NEDO-33148
Revision 2
Rev.2: DRF 0000-0055-5172
Class I
August 2006

LICENSING TOPICAL REPORT

**GUIDANCE FOR SEPARATION OF LOSS OF OFFSITE
POWER FROM LARGE BREAK LOCA**

D - RESPONSE TO RAIs

Figure C.3-4 Large LOCA Event Tree

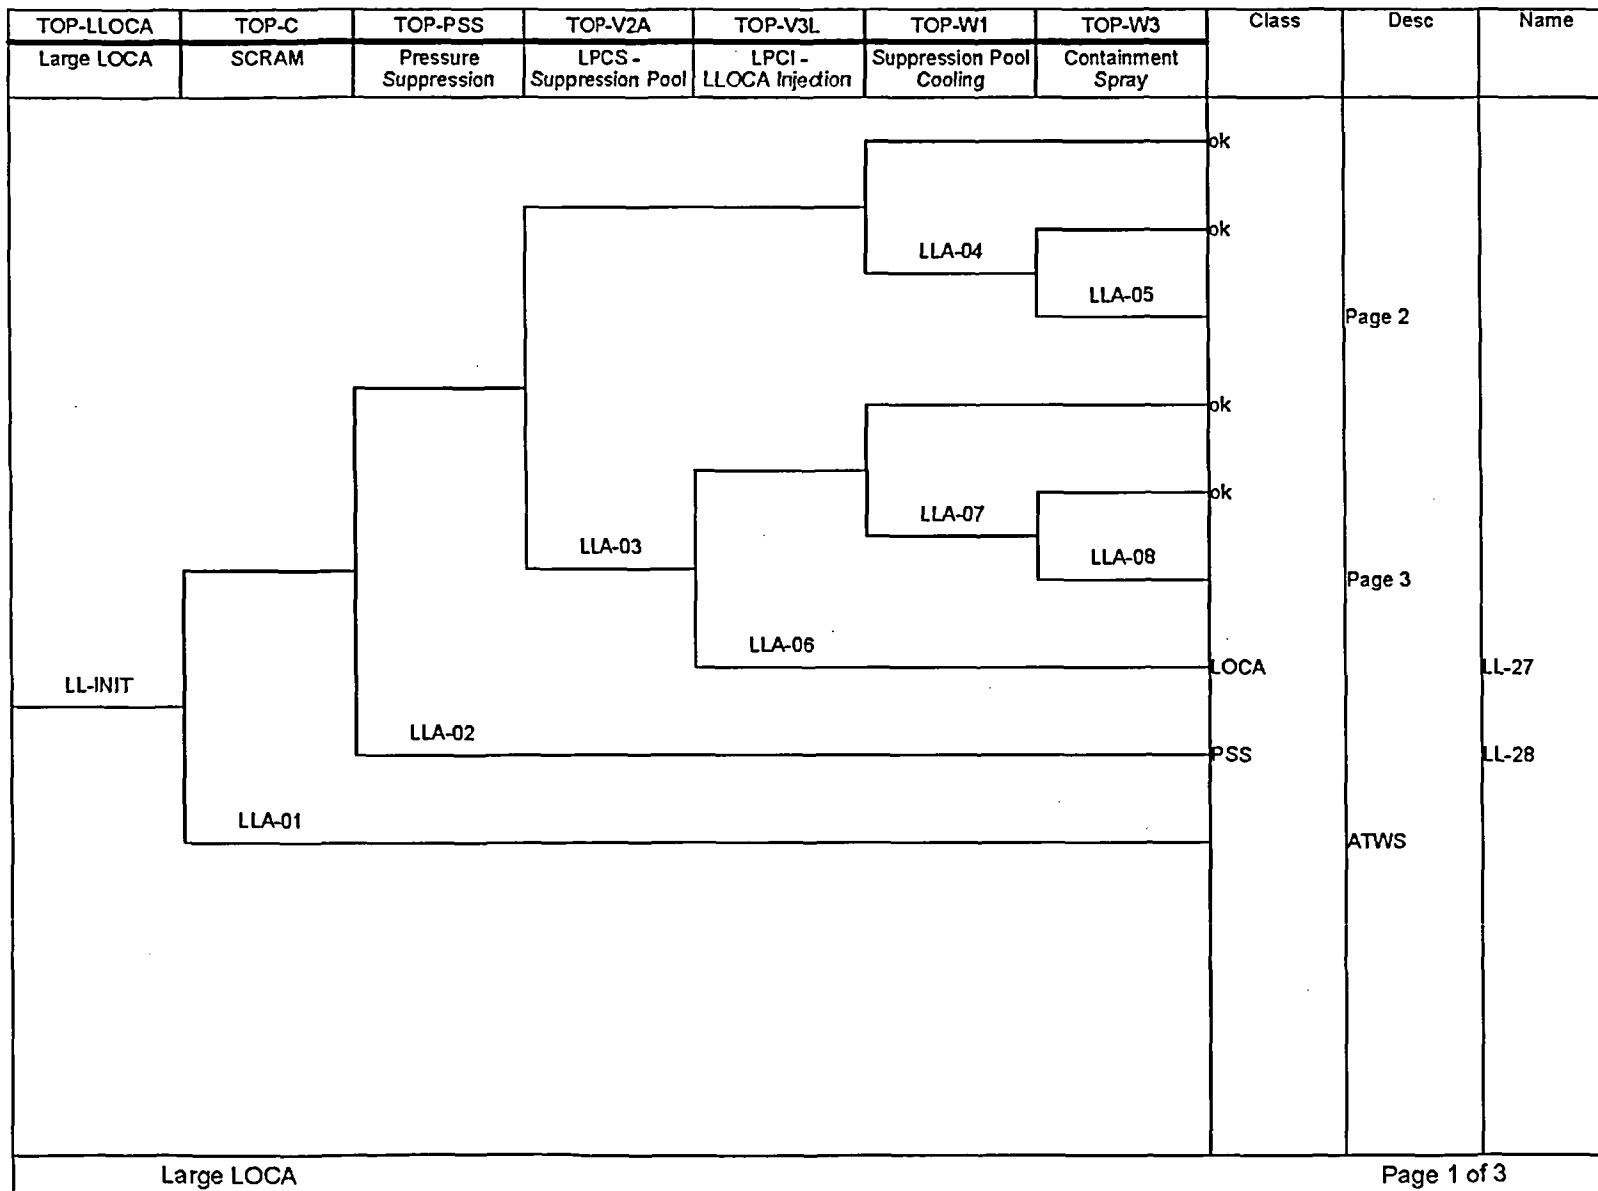
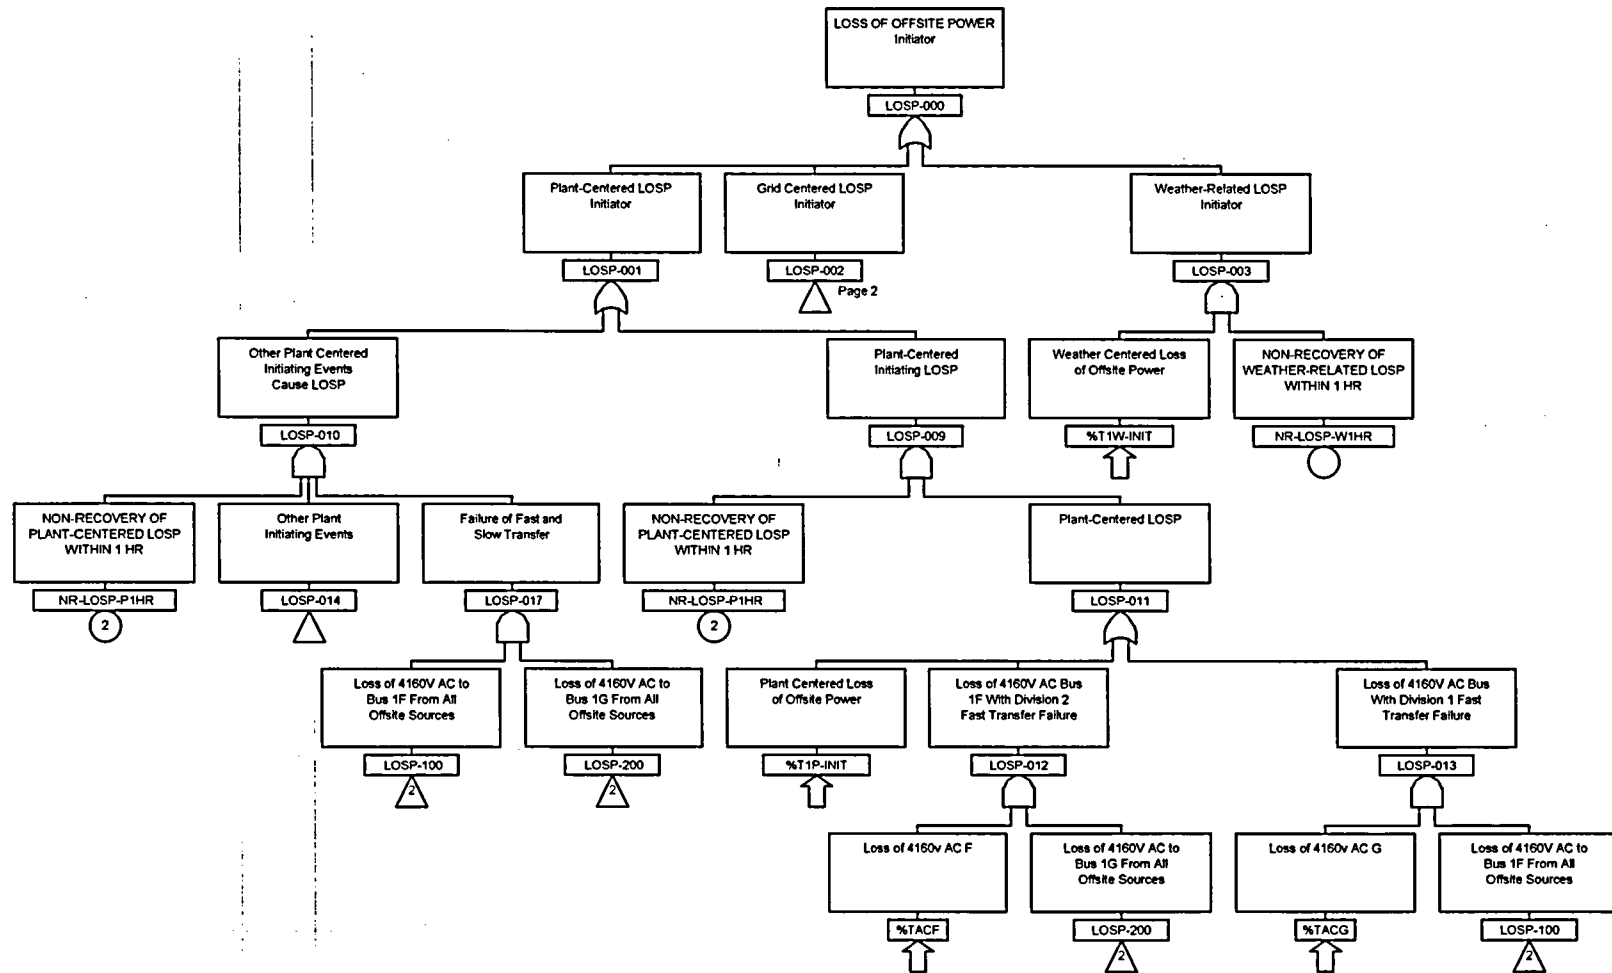
Source	RAI #	Question	Response
PRA	8	<p>Figures C.3-4 and C.4-1 present the LBLOCA event tree and fault tree for LOOP events, respectively. The event tree includes top events "TOP-LOSP2 (Offsite Power Available)" and "Recovery." The latter top event appears to be related to recovery of offsite power because the associated branches have the label "REC-LOSP-G6H." It appears that the LBLOCA event tree and fault tree for LOOP events are linked or combined in some way, but a description of the way they are linked was not found in the TR.</p> <p>Please describe in detail how a licensee would be expected to model the consequential LOOP event together with the LBLOCA event tree. The NRC staff notes that a consequential LOOP is likely to be delayed; i.e., not coincident with the LBLOCA. Please discuss in detail how a licensee would determine a plant-specific, best-estimate timing for the LOOP resulting from the LBLOCA, and how the delayed LOOP would be modeled in the PRA.</p>	<p>Although the logic model allowed for the possibility, there are no cutsets that actually reach the REC-LOSP-G6H branch (the conditional probability of TOP-LOSP2 failure is 0.0 for these branches on the large break LOCA event tree); therefore the large break LOCA and the 6-hour recovery factor are not combined in the solution of the event tree. This is because this branch is examined only in scenarios where initial injection is successful, and power must be available for initial injection to be successful. Offsite power recovery is examined only to determine the availability of containment heat removal.</p> <p>See the responses to PRA Question 4 (above) for a description of how the licensee would model recovery of consequential LOOP.</p> <p>Even though the BWROG refers to the LOCA/LOOP as being simultaneous events, in reality the LOOP could occur a few minutes after the LOCA and still be considered a LOCA/LOOP event. BWROG evaluation considers both the simultaneous and delayed (by a few minutes) events to lead to core damage. "A few minutes" is determined by the time for reflooding to occur. Any LOOP after the reflooding is not specifically modeled in the PRA and is not considered to be risk significant.</p>

Figure C.4-1 Loss Of Offsite Power Initiating Event Logic (Page 2 of 2)

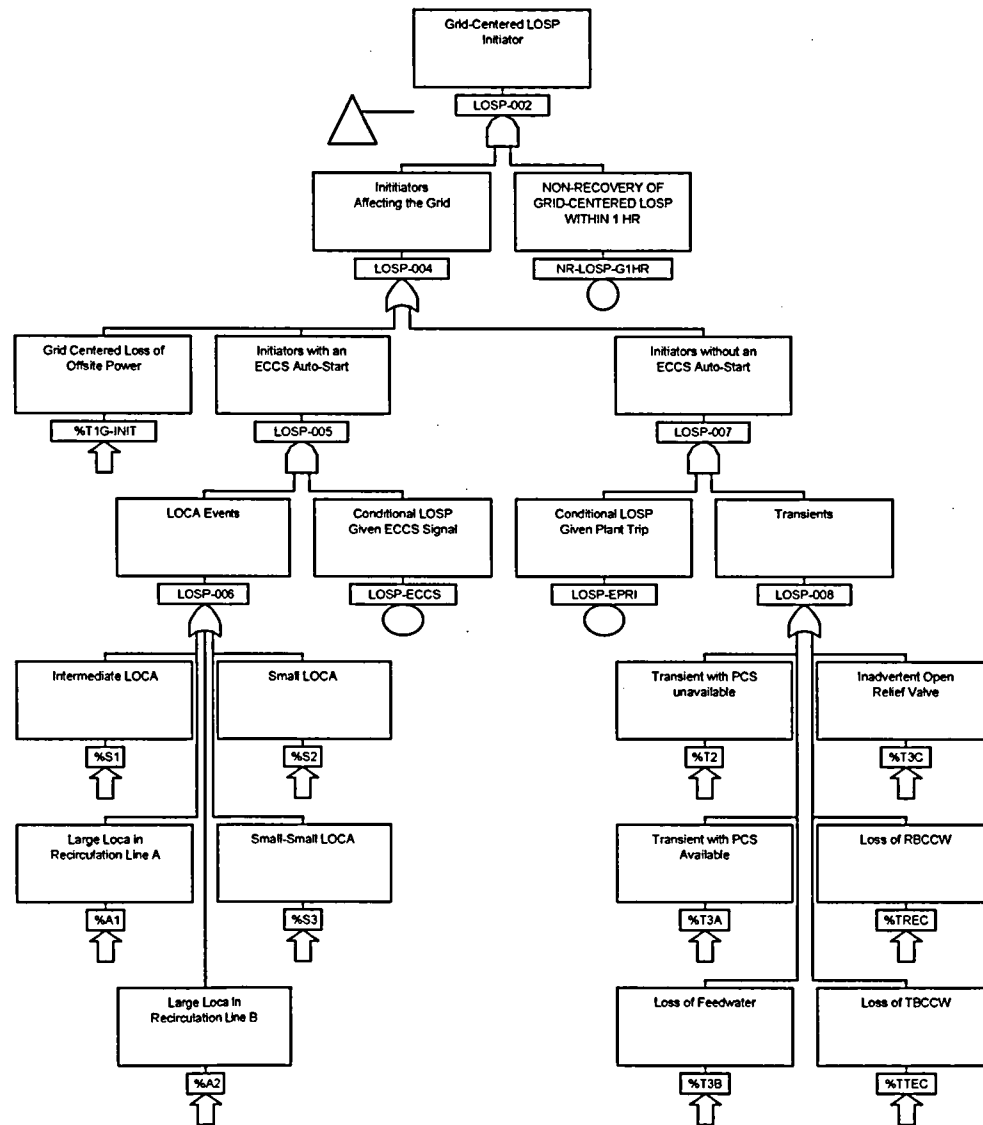
PRA	7	<p>Page 2 of Figure C.4-1 models conditional LOOP events (LOOP given LOCA and LOOP given transient) as part of grid-centered events. According to this figure, a LBLOCA and LOOP are linked with an "AND" gate together with the recovery of offsite power within one hour. In other words, solving the top gate for grid-centered events would yield the following cutset (among other cutsets): LBLOCA * LOOP * NR-LOOP-1HR</p> <p>where NR-LOOP-1HR is the failure to recover offsite power within one hour. This cutset does not appear realistic because a consequential LOOP would occur shortly after a LBLOCA, so the time available for recovery of offsite power is very short, and probably cannot be credited.</p> <p>Please describe how a licensee would be expected to model recovery of the consequential LOOP given a LBLOCA in their risk assessments. Describe and justify the use of any recovery of offsite power.</p>	<p>The logic presented in this figure is not called in the quantification of the large LOCA event tree. When quantifying the large LOCA tree, the BWROG used a version that did not include a recovery factor. The figure presented the base logic rather than all of the permutations. The BWROG reviewed the cutsets from the solutions and confirmed that none of the large LOCA scenarios include this recovery of offsite power.</p> <p>LOOPS following large break LOCAs are assumed to lead directly to core damage. Therefore, licensees need not model recovery of consequential LOOP given a large break LOCA.</p>

Figure C.4-3 Medium LOCA Conditional Core Damage Probability

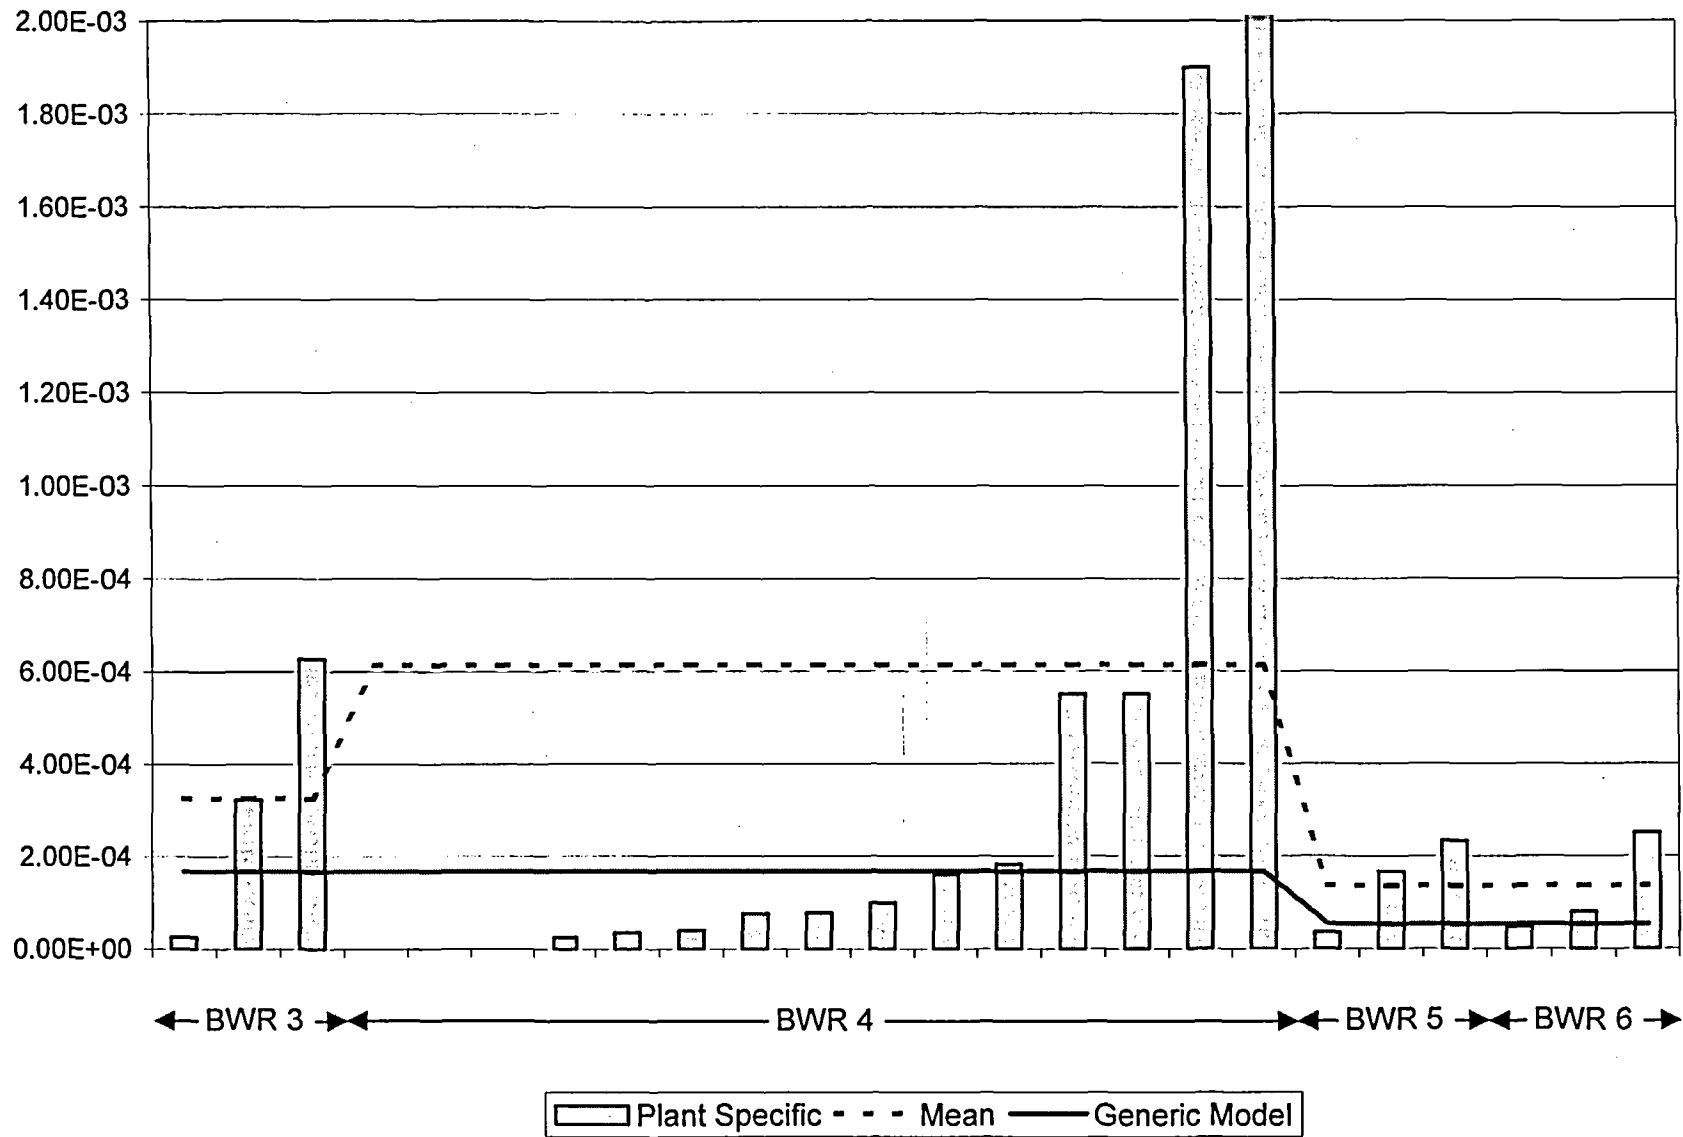
Source	RAI #	Question	Response
			occurrence.
PRA	19	<u>Miscellaneous Comments</u> The TR contained a number of administrative and clerical errors, including:	See below for responses to Comments 19-1 through 19-8.
PRA	19-1	Section C.4.5, first paragraph, refers to General Design Criteria (GDC) 16 vice GDC 17.	The typographical error will be corrected in revision of TR to reflect correct GDC number (GDC 17).
PRA	19-2	Section C.4.5 states, "Figure C.4-3 shows the generic model logic for loss of offsite power events." However, Figure C.4-3 is entitled "Medium LOCA Conditional Core Damage Frequency [sic]." The correct reference appears to be Figure C.4-1, and it would appear that Figure C.4-3 should refer to "probability" vice "frequency."	The typographical error will be corrected in revision of TR to reflect correct figure number C.3-2 (LOSP event tree). "Frequency" will be changed to "Probability" on Figure C.4-3.
